## DESCRIPTIVE REPORT

Field No. WH-10-1-66 Office No. H-8902

Locality Vineyard Sound

HYDROGRAPHIC SURVEY REVIEW

Development of Alleghany Rock

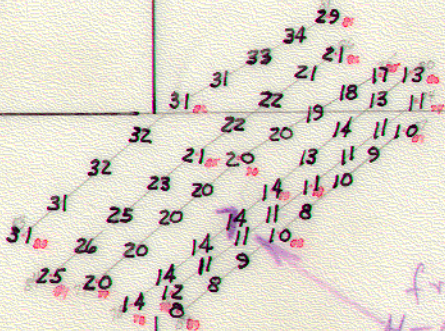
Alleghany Rock

Pre-Survey Review Item #3

Rock Development  
Lch #II  
Aug. 23, 1966  
WH-10-1-66  
"ad" day. 41°28'30"

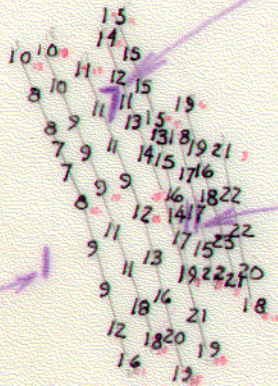
Pre-Survey Item #7 70° 35'
